LIGHTING PROPOSAL DOCUMENT

P2 BUILDING, EXTERIOR KINGS CROSS, LONDON

Document Reference: KXC-P2-001-J-00944-63-904

Stage 4.

Ground Floor - General Facade Lighting

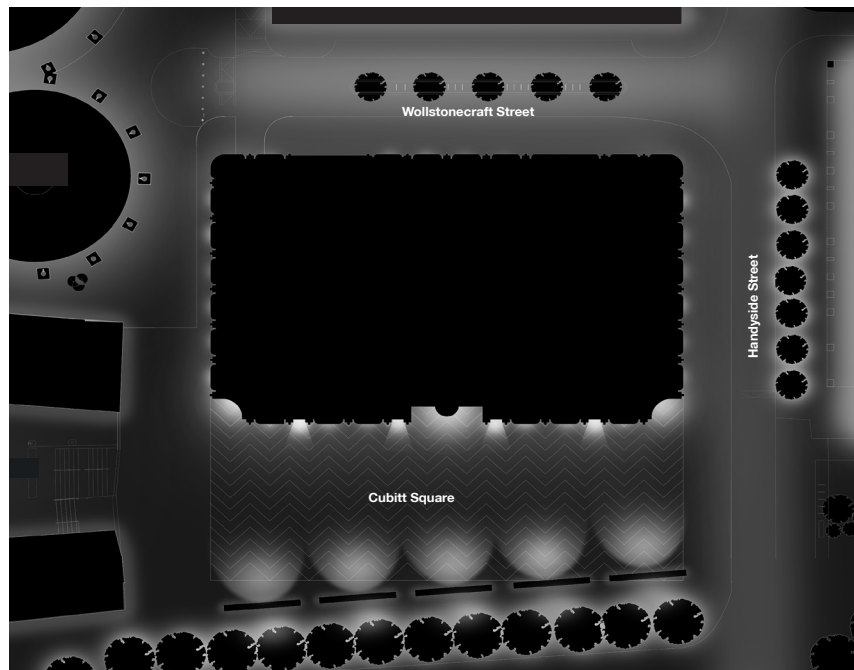
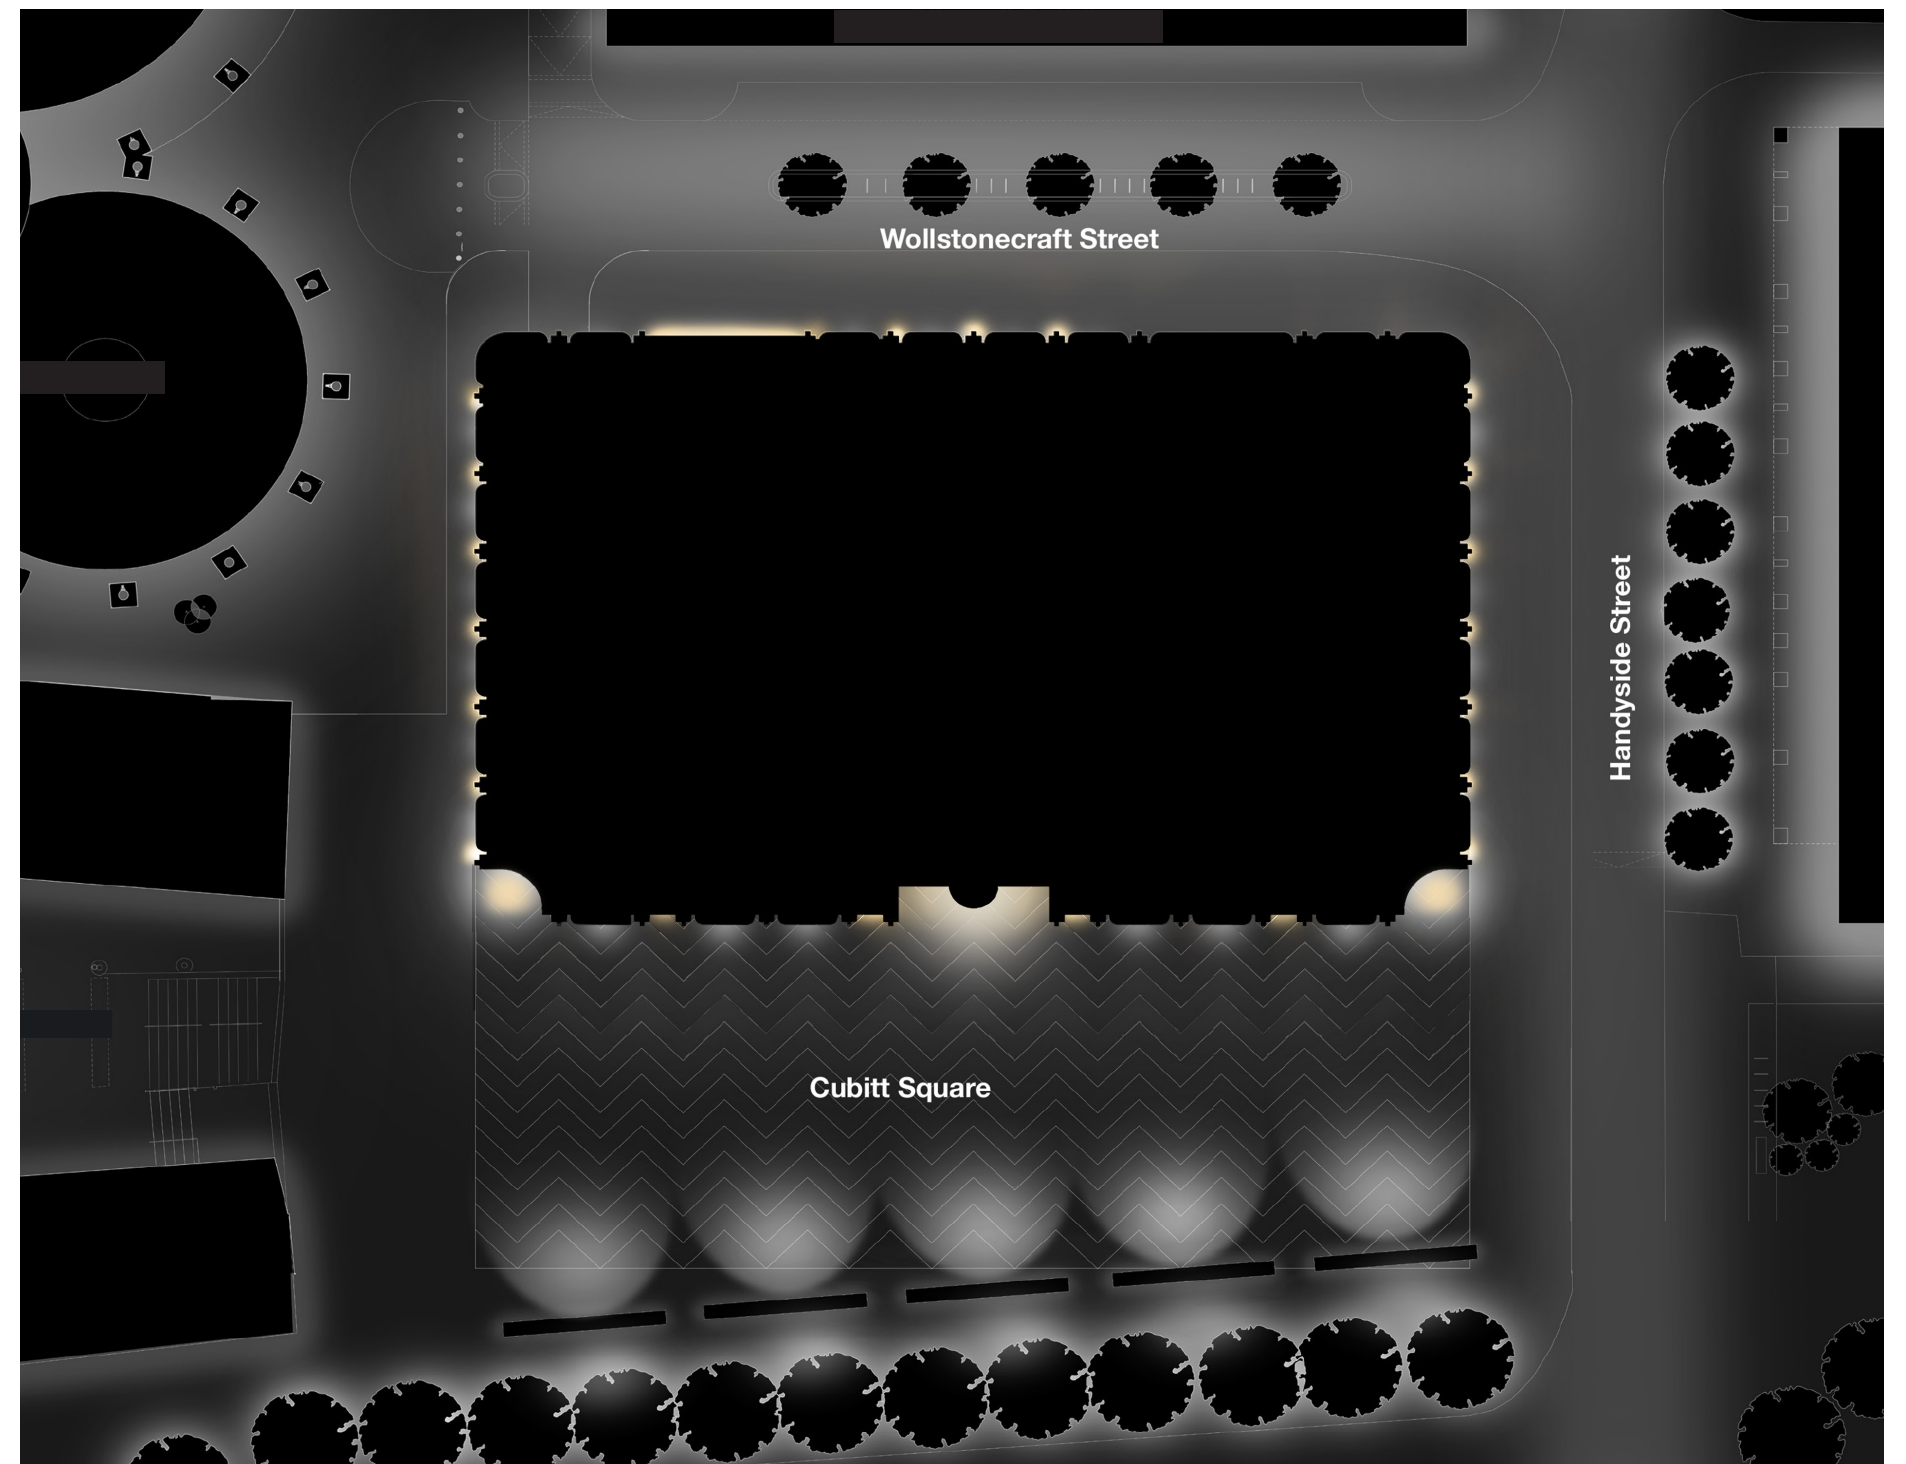
1. Reduced Reference XG, Loggia soffit recessed Downlighting.
2. Amended Direct / Indirect Wall Luminaire Layout and Quantity.

Ground Floor - Loggia Lighting

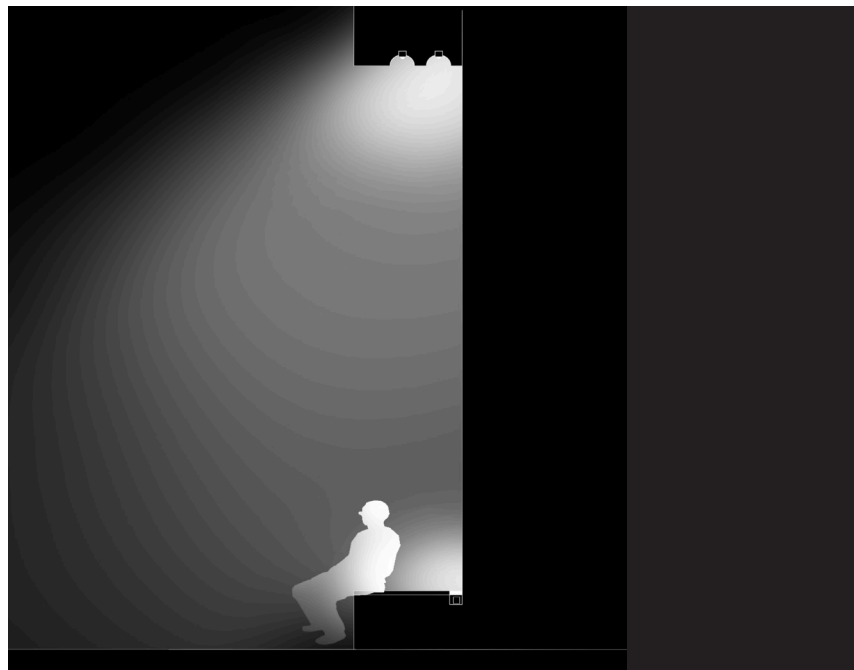
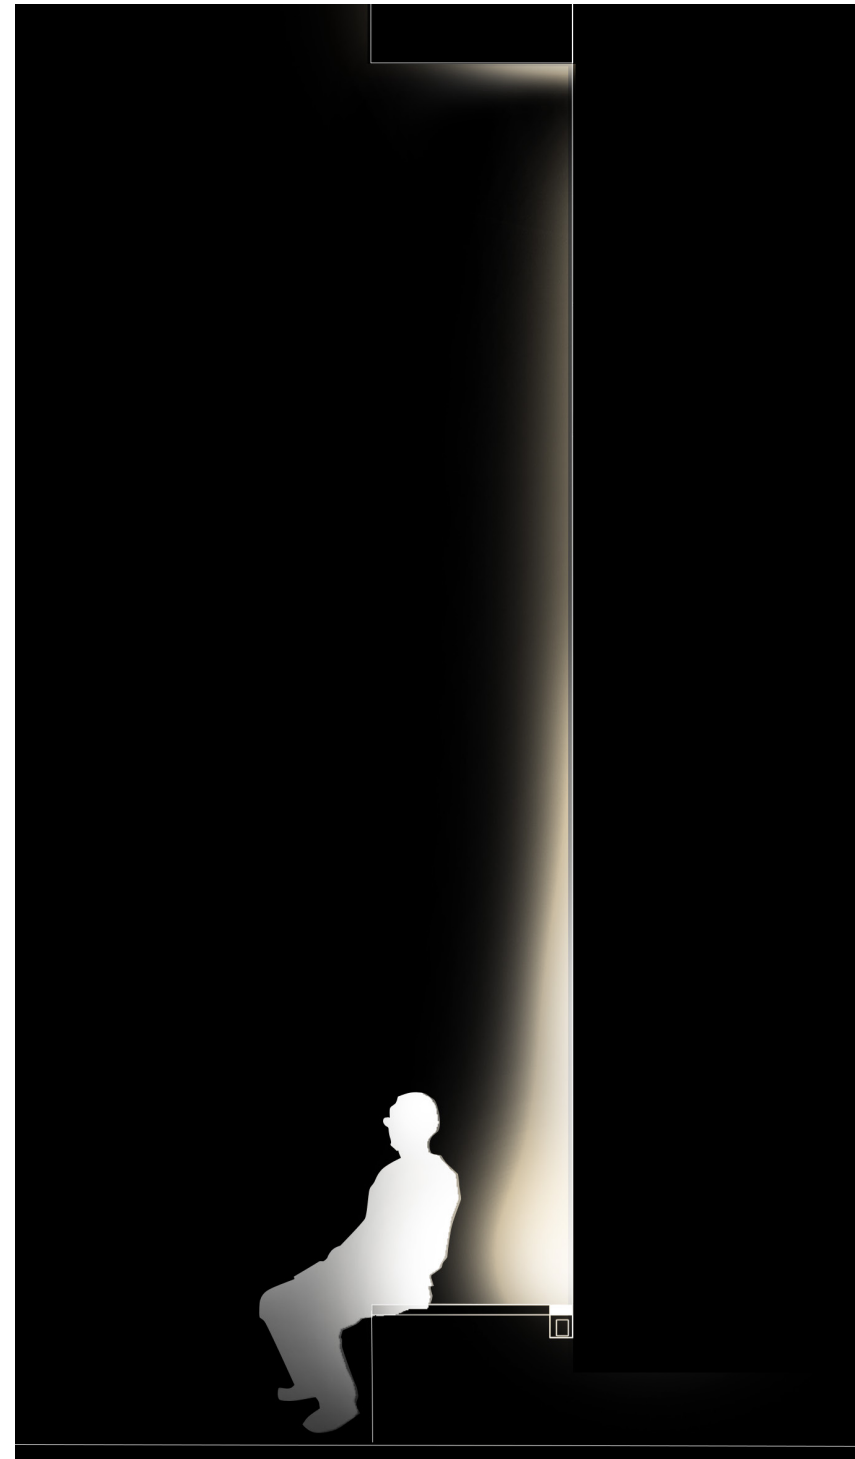
1. Removal of Reference XG, Loggia soffit recessed downlights.
2. Respecification of Reference XB, linear LED uplight luminaires, to provide higher outputs.

Ground Floor - Feature Shutter Lighting

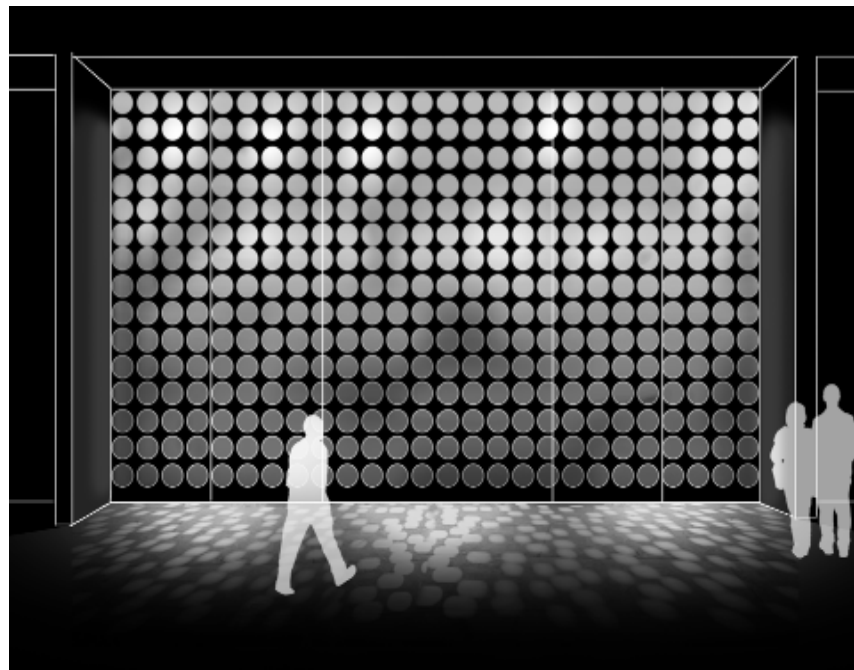
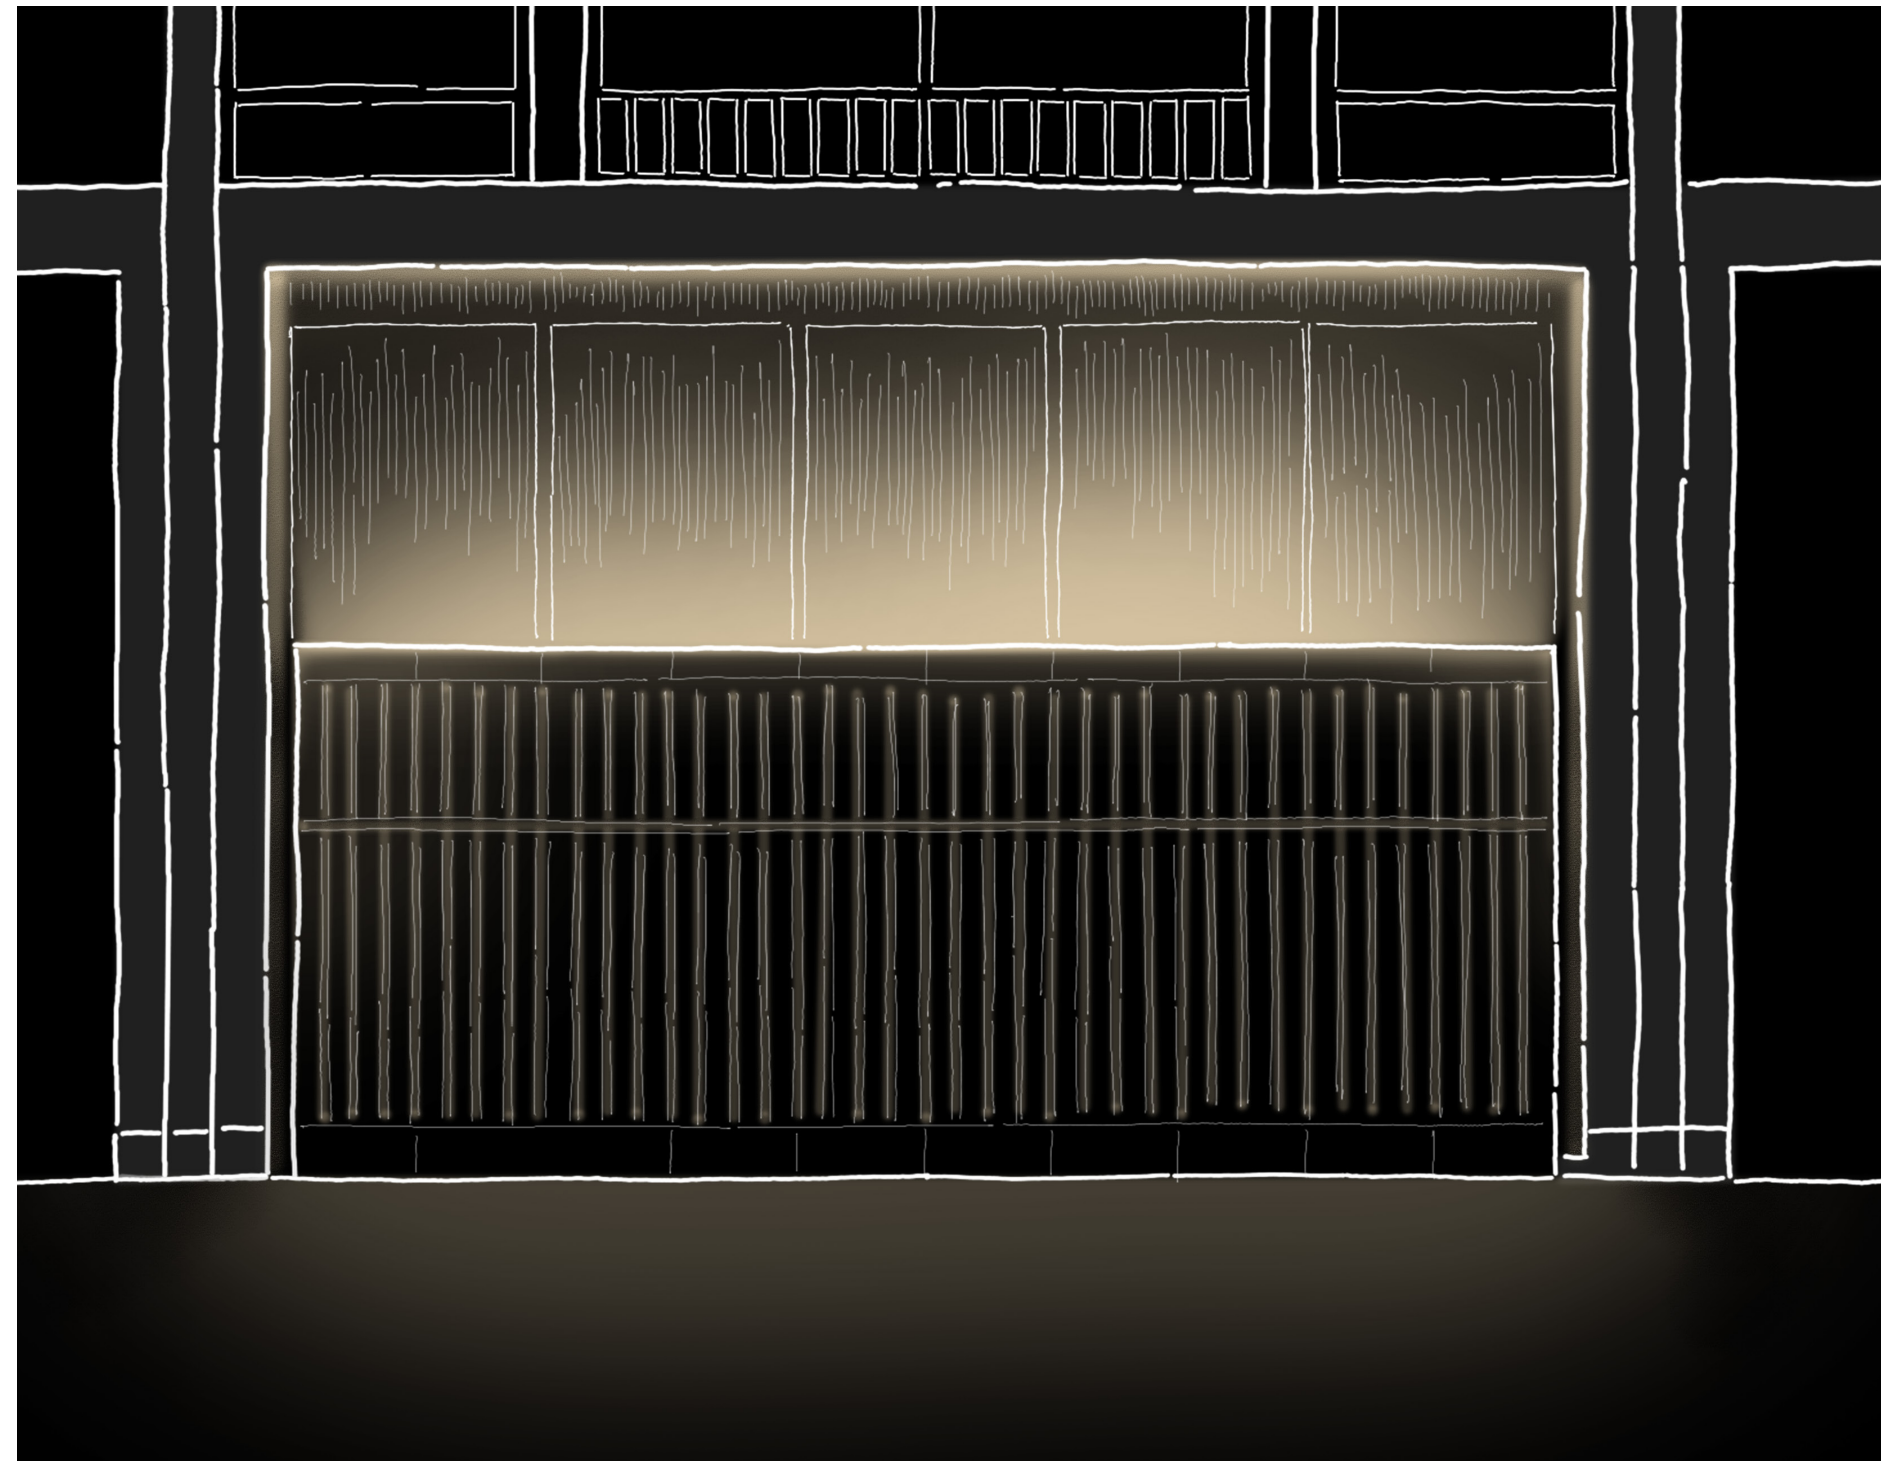
1. Amended Reference XJ arrangement.
2. Omitted feature flood lighting within loading bay.
3. Respecification of Reference XK linear luminaires to provide wash of illumination to feature facade detailing.

North Elevation - Facade Lighting

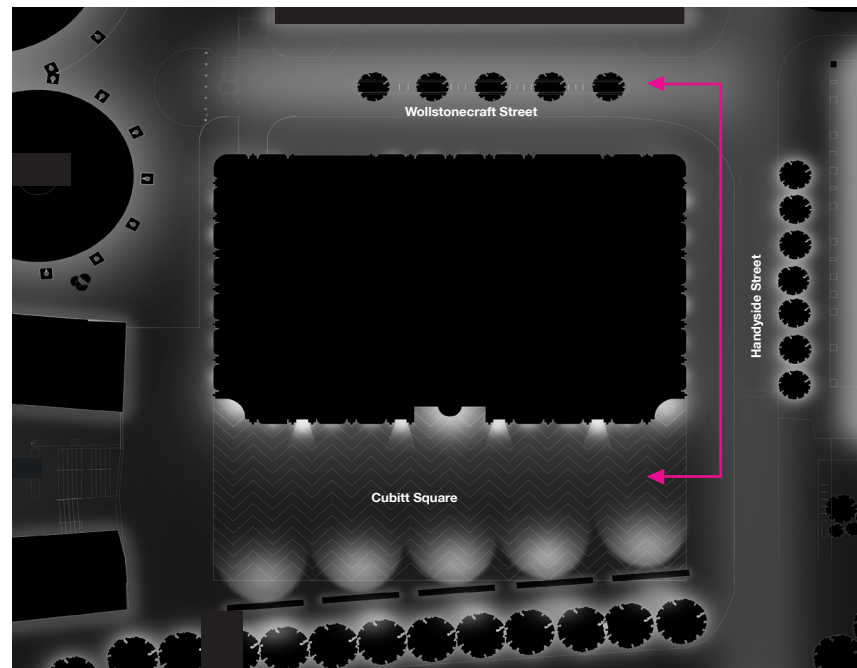
1. Respecification of Reference YD luminaires within fifth floor plants, for improved efficacies and BREEAM compliance. (LM/W).
